PRODUCT/PROCESS CHANGE NOTICE (PCN)

PCN #: **TB1711-03** DATE: **December 7, 2017**
Product Affected: **WLCSP-40, 52, 54**
(Refer to Attachment II for affected part#)
Date Effective: **March 7, 2018**

ATTACHMENT I - PCN #: TB1711-03

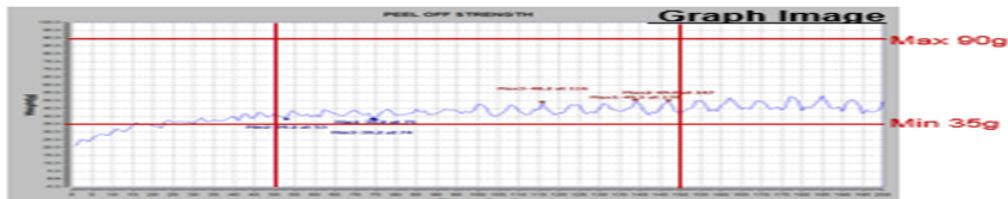
☐ Sealing & Peeling Quality : Pass

Item	E-pak eH52 (Heat Seal Type)	Result
Sealing Image		Pass
Peeling Image		Pass
